**METROPOLITAN GOVERNMENT OF NASHVILLE AND DAVIDSON COUNTY**

**STAFF RECOMMENDATION**  
**1504 Forrest Avenue**  
**February 17, 2016**

**Application:** New construction - addition  
**District:** Lockeland Springs-East End Neighborhood Conservation Zoning Overlay  
**Council District:** 06  
**Map and Parcel Number:** 08309038600  
**Applicant:** Mitch Hodge, S. Mitchell Hodge Architecture  
**Project Lead:** Melissa Sajid, melissa.sajid@nashville.gov

**Description of Project:** The applicant proposes a rear addition and side dormer additions on a contributing house.

**1 1504 FORREST AVE**  
A-1 1" = 20'-0"

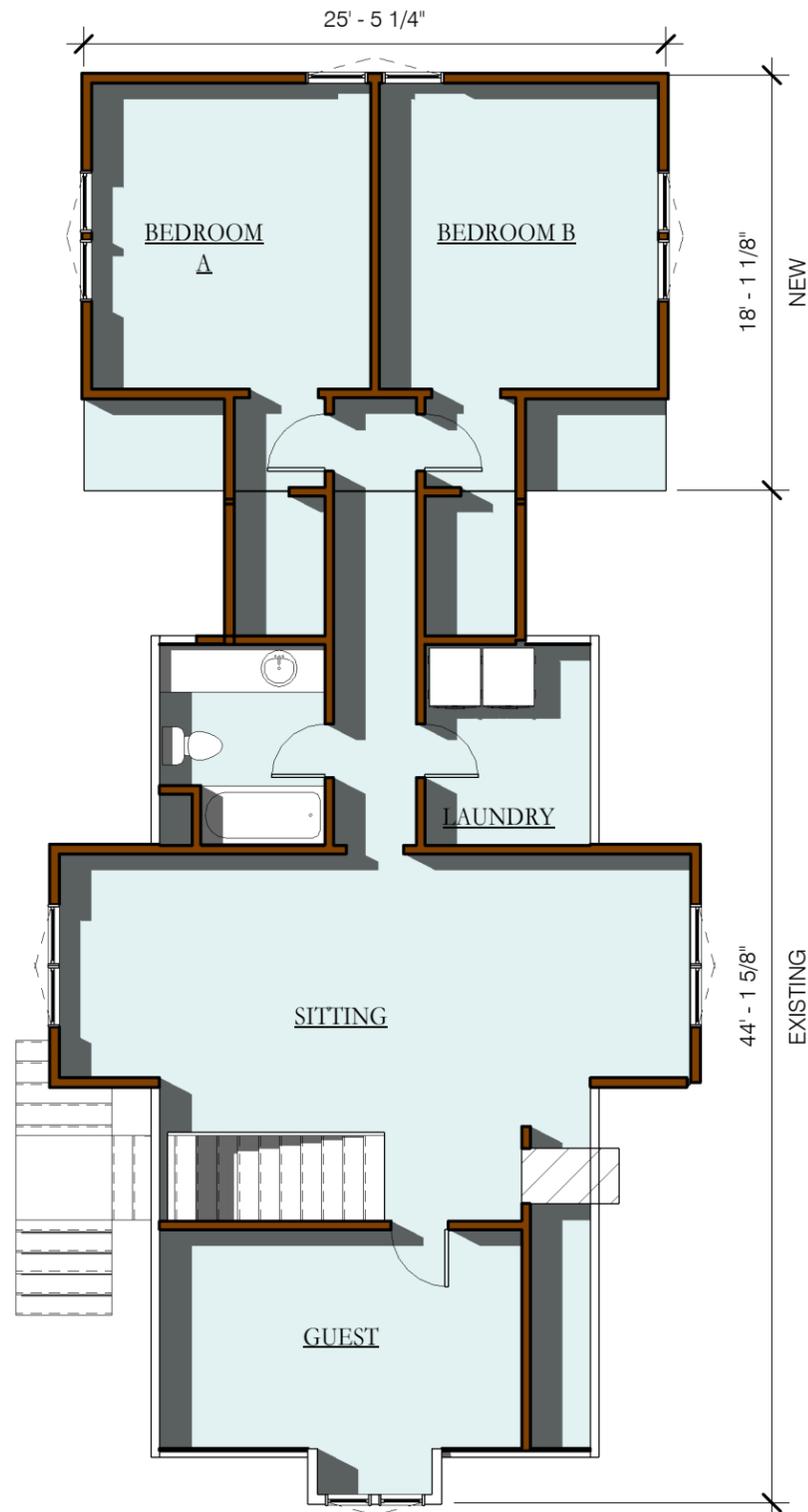
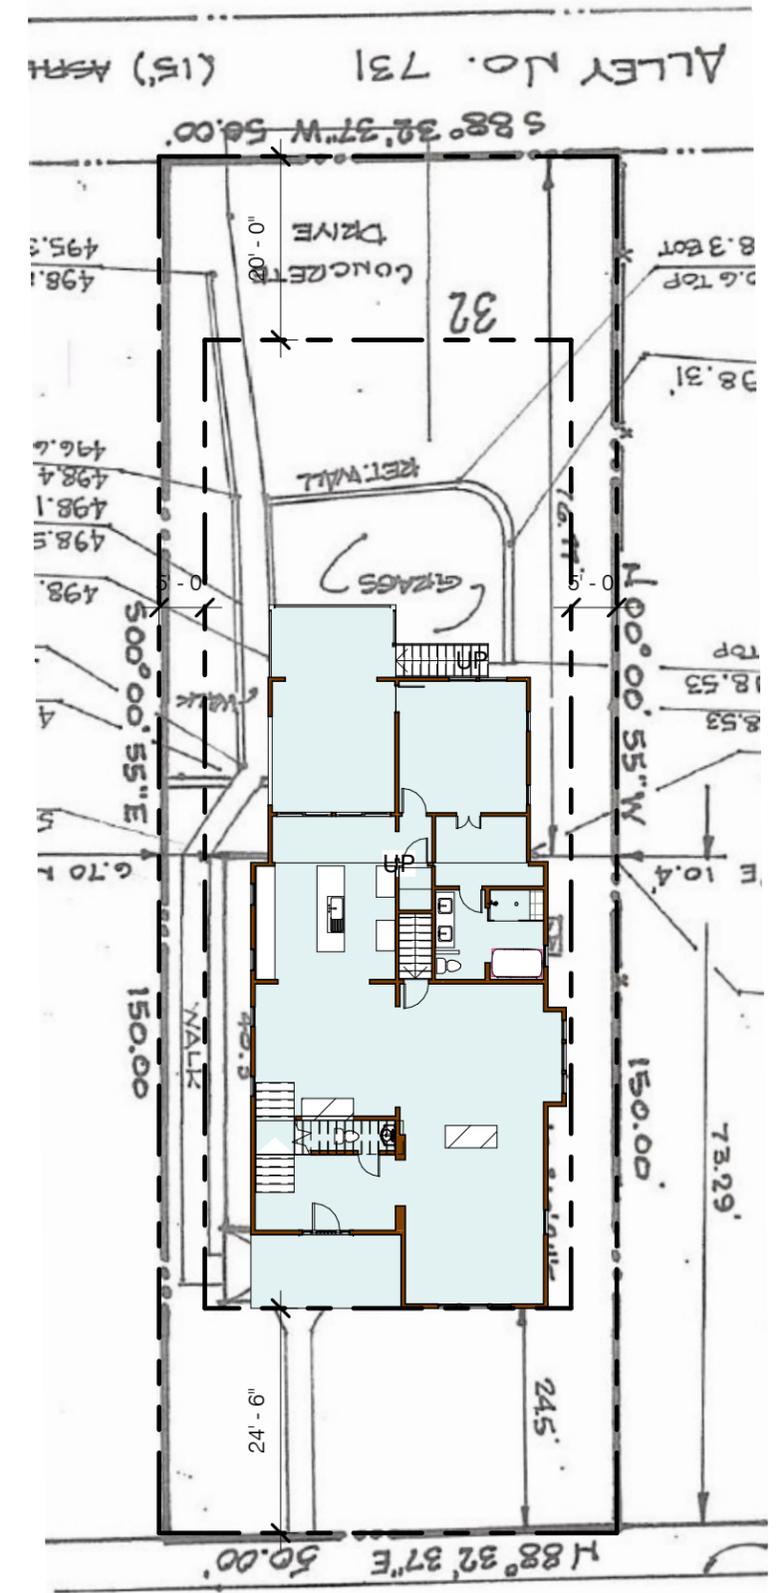
Setback: The setbacks will be twelve feet (12') on the left side, and nine feet (9') on the right side. The rear wall of the addition will be approximately forty-seven feet (47') from the rear property line. The setbacks for the addition meet the bulk zoning standards and are consistent with the historic context of the surrounding area. Therefore, staff finds that the project meets section II.B.i.c for setbacks.

Appurtenances & Utilities: The retaining wall shown on the plan is existing and constructed of brick. The location of the HVAC and other utilities was not noted. Staff asks that, if it is to be relocated, that the HVAC be located on the rear façade, or on a side façade beyond the midpoint of the house. With that condition, Staff finds that the project meets section II.B.1.i of the design guidelines.

ELEVATIONS

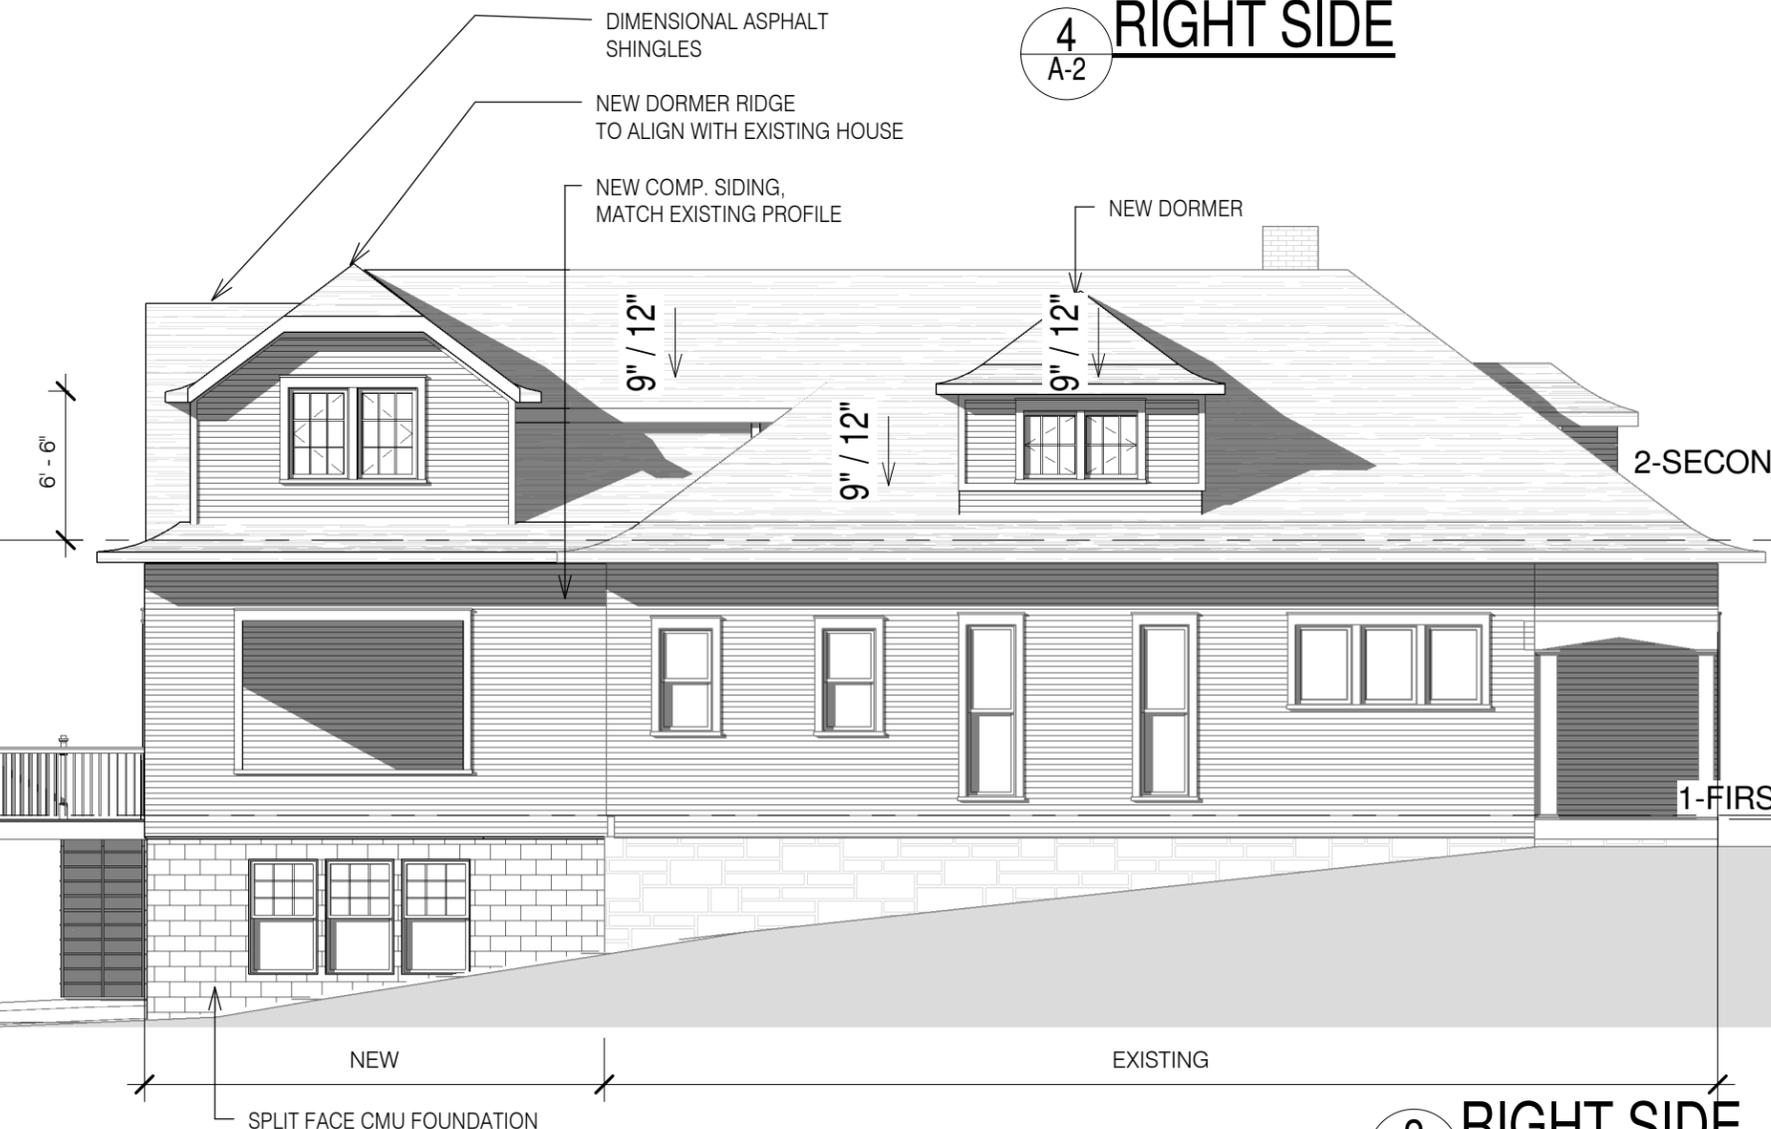
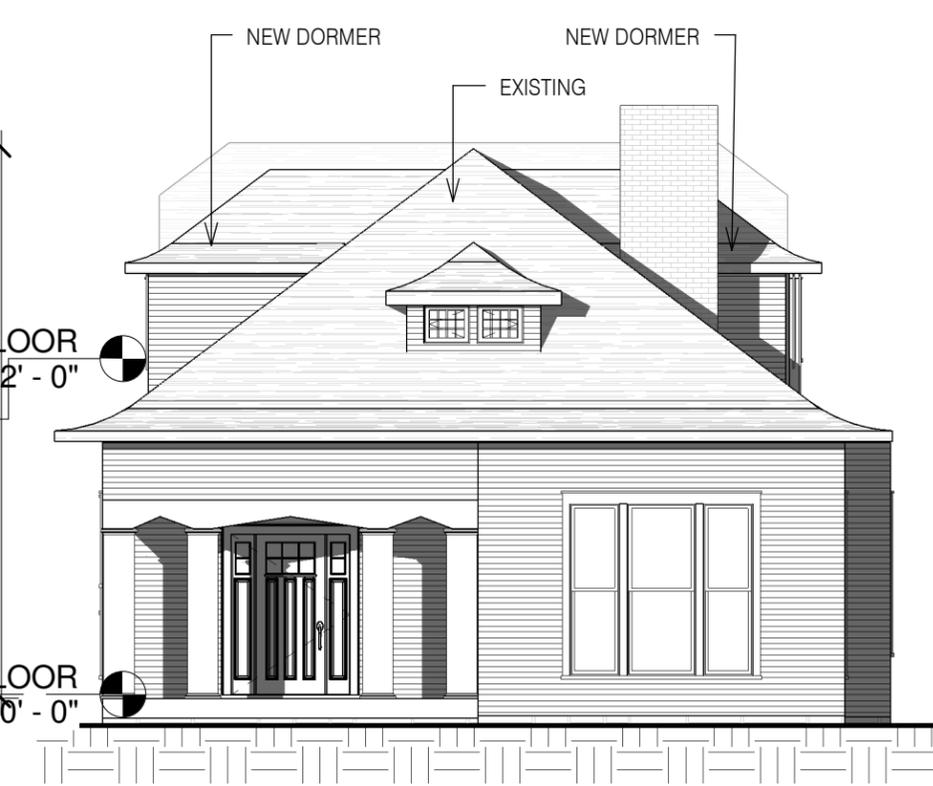
Roof form: The existing house has a hipped roof form with paired windows. The side dormers to be added to the existing house are also hipped with paired windows. Both side dormer additions are hipped and set back two feet (2') from the wall below. Generally, side dormers introduced on a historic building should be of a similar scale and size to any existing historic dormers. In this case, the existing dormer is approximately five feet (5') and four feet (4') tall. The proposed side dormer is approximately nine feet by nine feet (9' x 9'). Historically, dormers often are similar in width to window openings below. The existing dormer is not large enough to duplicate and have usable space on the second level and the propose dormers are similar in width to the historic front window, therefore staff finds them to be appropriately scaled.

The rear addition proposes a rear facing gable with a roof pitch of 9:12, which matches that of the historic house. The rear addition also includes two side facing clipped dormers. The dormers are set back two feet (2') from the wall below but appear to pull off the existing ridges. Staff recommends a condition that the dormers sit in at least six inches (6") from the existing ridges. As the roof form on the addition is compatible with the historic house, Staff finds that the project meets section II.B.1.e of the design guidelines.

- The dormers on the rear addition shall sit in at least six inches (6") from the existing ridges;
- The trim, window, and door selections are approved by MHZC Staff prior to purchase and installation; and,
- The HVAC if it is to be relocated, that the HVAC be located on the rear façade, or on a side façade beyond the midpoint of the house.
